# Access Compliance Report

## Public Rights-of-Way

### (Curb Ramps)

Intersection ID: N/A	Main Street: TAMARACK DR	Cross Street: SINGLELEAF LN	Location: S
ADA ID: F18BFE3FBDF6	Ramp Type: Perp	Initial Pass/Fail: Fail	Overall Compliance: No
		Severity Score: 1.25

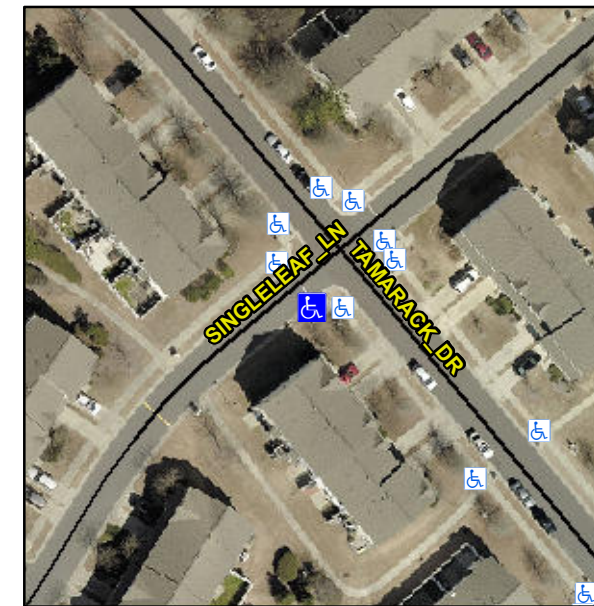
**R304.5.3**

Compliance	Description	Data	Compliance	Description	Data
N/A	Ramp Length (in)	48.0	Yes	Ramp Slope (%)	5.6
Yes	Ramp Width (in)	48.0	No	Ramp XSlope (%)	3.4
N/A	Flare Type LT	N/A	N/A	Flare Type RT	N/A
N/A	Flare Slope LT (%)	N/A	N/A	Flare Slope RT (%)	N/A
N/A	Flare Traversable LT?	No	N/A	Flare Traversable RT?	No
N/A	Landing Length (in)	N/A	N/A	DWS Provided?	N/A
N/A	Landing Width (in)	N/A	N/A	DWS Contrast?	N/A
N/A	Landing Slope (%)	N/A	N/A	DWS Length (in)	N/A
N/A	Landing X Slope (%)	N/A	N/A	DWS Full Width?	N/A
N/A	Landing Curb? (Y/N)	N/A	N/A	DWS Offset (in)	N/A
N/A	Shared Landing?	N/A			
N/A	Gutter Ponding?	N/A	N/A	Gutter Slope (%)	N/A
N/A	Gutter Lip Ht (in)	N/A	N/A	Gutter X Slope (%)	N/A
N/A	Painted X Walk1?	No	N/A	Painted X Walk2?	N/A
	X Walk 1 Direction	To NW		X Walk 2 Direction	N/A
N/A	X Walk 1 Width (in)	N/A	N/A	X Walk 2 Width (in)	N/A
	X Walk 1 Slope (%)	0.9		X Walk 2 Slope (%)	N/A
	X Walk 1 X Slope (%)	1.6		X Walk 2 X Slope (%)	N/A

**Remove & Replace Entire Ramp.**
